14215 FOUNTAIN LN

Mecklenburg County

RE: Property located off Fountain Lane
FILE: 511B/8382A
PARCEL: 199-111-22

MECKLENBURG COUNTY ENVIRONMENTAL HEALTH
SITE EVALUATION REPORT
SERIAL NUMBER 12737

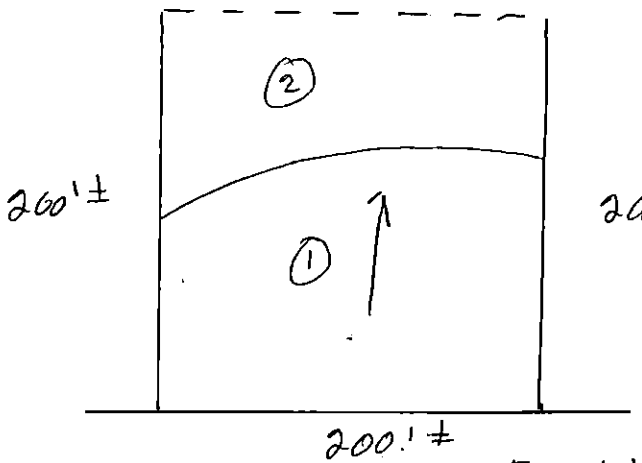
Comments: Not sure if 100% Repair required

FACTORS	AREA 1	AREA 2	AREA 3	AREA 4	AREA 5	AREA 6
Topography	(S) PS U 2-8%	S PS (U) complex slopes	S PS U	S PS U	S PS U	S PS U
Texture	S PS (U) Expansive clay	S PS U —	S PS U	S PS U	S PS U	S PS U
Structure	S (PS) U Sub L Blocky	S PS U —	S PS U	S PS U	S PS U	S PS U
Drainage	S (PS) U ~36" To water	S PS U —	S PS U	S PS U	S PS U	S PS U
Depth	S PS (U) 10-31"	S PS U —	S PS U	S PS U	S PS U	S PS U
Restrictive Horizons	S (PS) U ~36"	S PS U —	S PS U	S PS U	S PS U	S PS U
Available Space	S (PS) U	S PS U	S PS U	S PS U	S PS U	S PS U
Other (specify)	S PS U	S PS U	S PS U	S PS U	S PS U	S PS U
Soil Group/Series	Mecklenburg-Lic	Complex Slopes				
Area Classification	S PS (U)	S PS (U)	S PS U	S PS U	S PS U	S PS U
